Project Name: Earlywine Golf Course	Change Order Request (COR):	43
WLM Project Number: 1003	Date:	9/5/2023
General Description: Hall of Fame Wood Light Box

EARLYWINE GOLF COURSE NEW CLUBHOUSE

S. PORTLAND & W. 119th AVE.
 OKLAHOMA CITY, OK

DRAWING NO.
 C4.01A

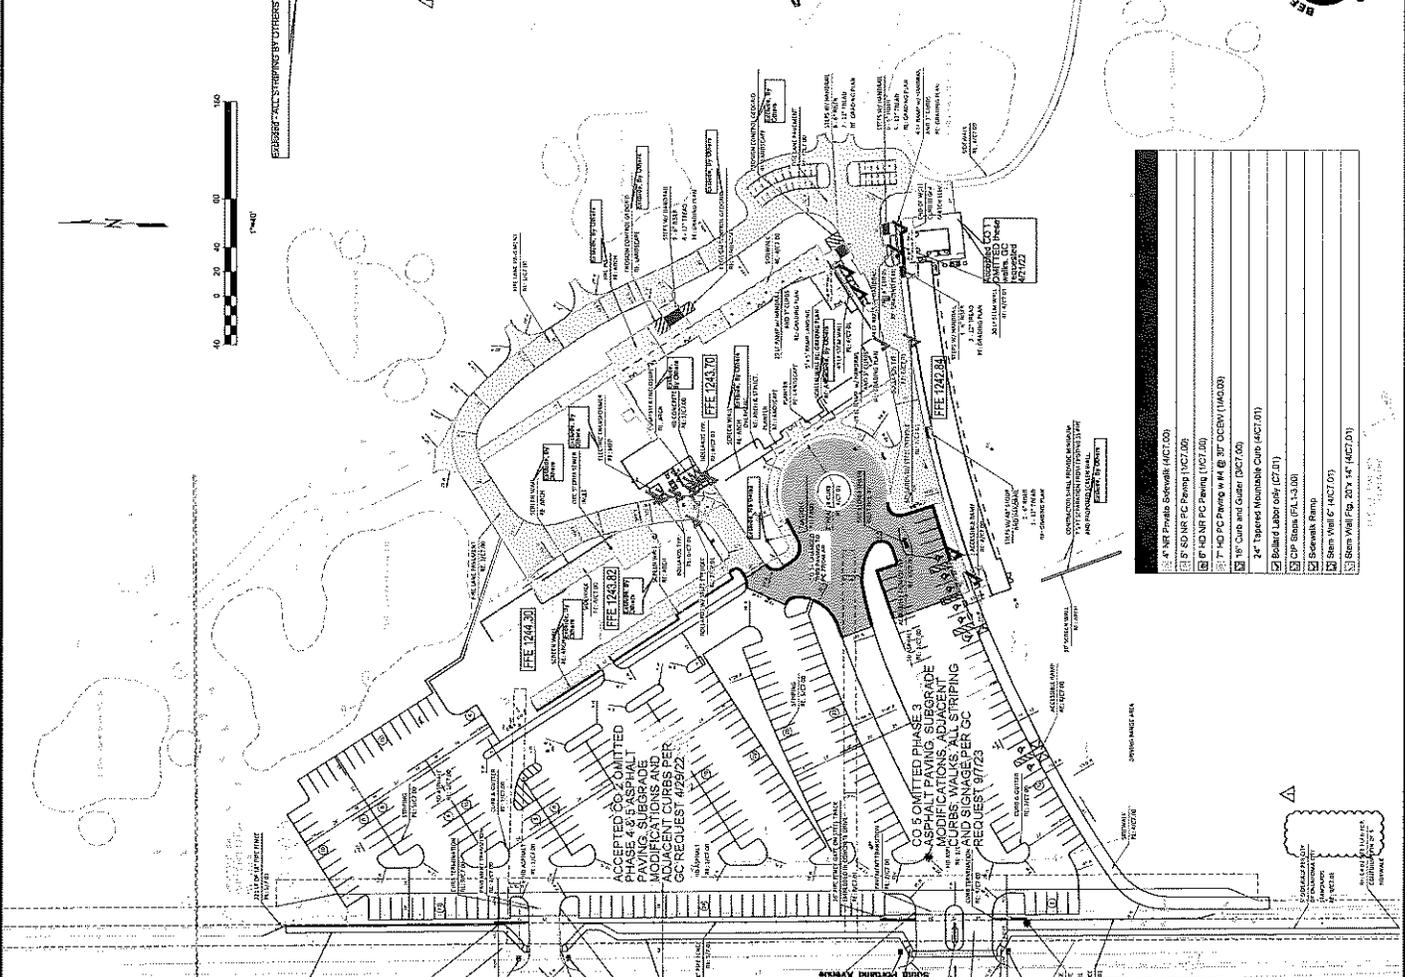
See attached markup.

Everything west of the red line is being REMOVED from your scope.

Everything else east of that line that was asphalt needs to switch to Concrete Paving.

I need you to ADD BACK IN the 5 light pole bases from Phase 4 and 5. (All Light Poles to be poured together)

TOTAL CREDIT AMOUNT - (\$207,375.00)
CREDIT FOR PREVIOUS INCREASES (ASPHALT AND CONCRETE) - (\$14,950.00)
COST TO SWITCH ADDED PAVING FROM ASPHALT TO CONCRETE - \$9,500.00
ADD BACK IN 5 LIGHT POLE BASES IN PH 4/5 - \$2,500.00

RFI #	42
	DATE	11/14/2023
	DATE NEEDED BY	ASAP
TO: GSB Architects	PROJECT NAME	Earlywine GC
	PROJECT #	181588

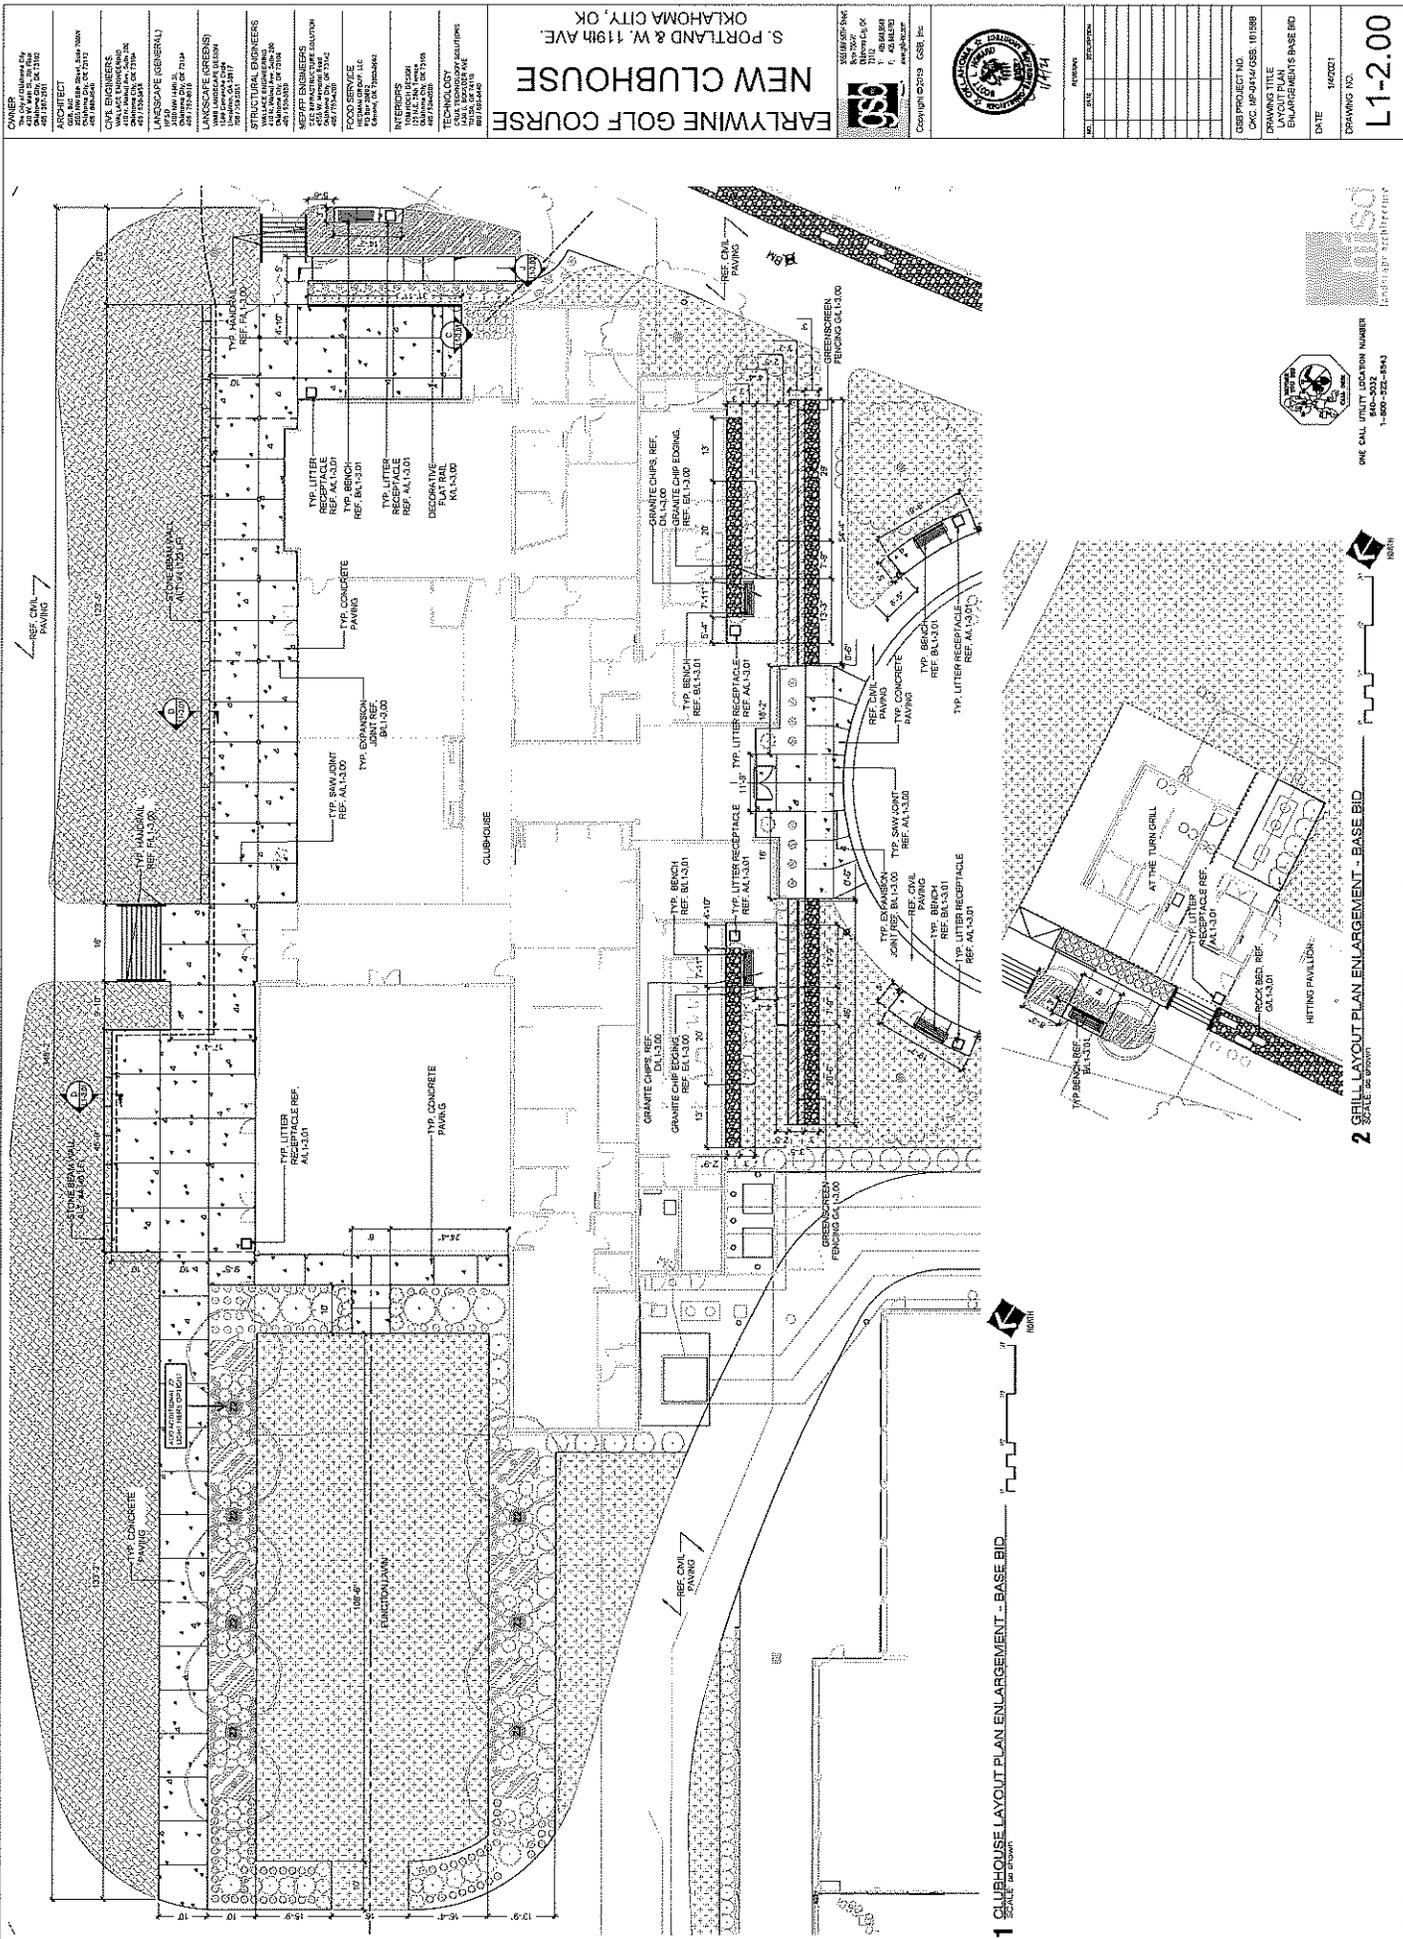
1) The light poles (Z2) for the function lawn on E1.01 Electrical Site Plan were drawn with the Alternate banquet room accepted. Since the alternate was not accepted, the lights are shifted far away from the building. Using L1-2.00 can the light poles be located on this drawing as the Function Lawn is being built to these dimensions with the landscaping as shown. Please Advise.

We have shown the Z2 lights in our preferred locations on the attached drawing. We have recommended adding an additional Z2 light as an option on the east side of the lawn closest to the building.

Earlywine Golf Clubhouse RFI 039 - S3 Light Fixture

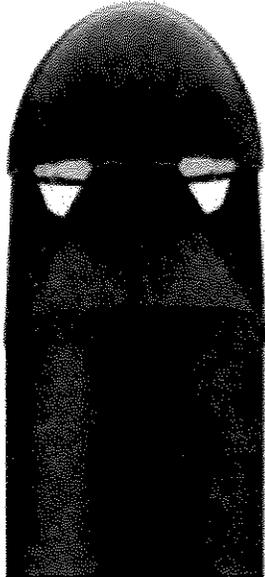
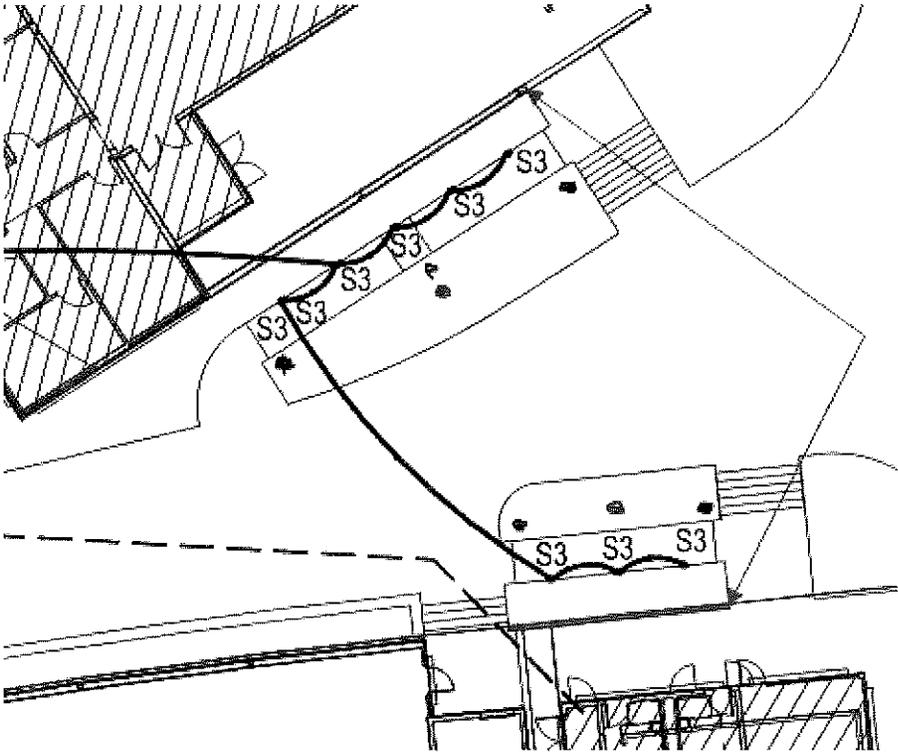
1) The S3 Light Fixtures as shown on E1.01 are to illuminate the ramps at the clubhouse and hitting pavilion. There was a slight oversight in thinking the retaining wall was abutting the ramp, but is in fact 5' away. Refer to the attached sheets for the grades and locations of the retaining wall. In order to make these lights work they will have to mount in the 8" sidewalk turn down that sits on top of each wall (Detail 4/C7.01). The lights near the top of the ramps may only be 3-4" above finished grade. The other issue is there are numerous large shrubs and plants that plant right in front of these lights, so they may not be visible at all. Three thoughts, install as shown in the turn down, try and install in the stairs at each location, or try and offer credit not to install at all. Our only thought on stairs is they are 5.5" tall, so they may take up most of the riser. Please advise.

We understand the change in the retaining wall, with the landscape between the ramp and the retaining wall the step lights will not work in this application.
Per Section 1008 in the IBC, we must maintain light at the steps and ramps.

CEC recommends getting credit back on the step lights and recommends one of these two options:

Item 1

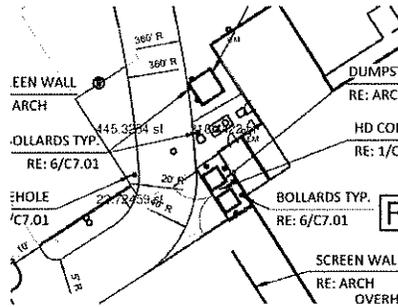
- Place 790 SF of 4" Non- Reinforced Concrete Sidewalk

Item 2

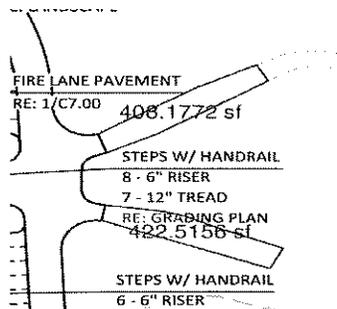
- Place 830 SF of 5" Non-Reinforced Concrete Cart Path w/ 50 LF of Transitional Curb
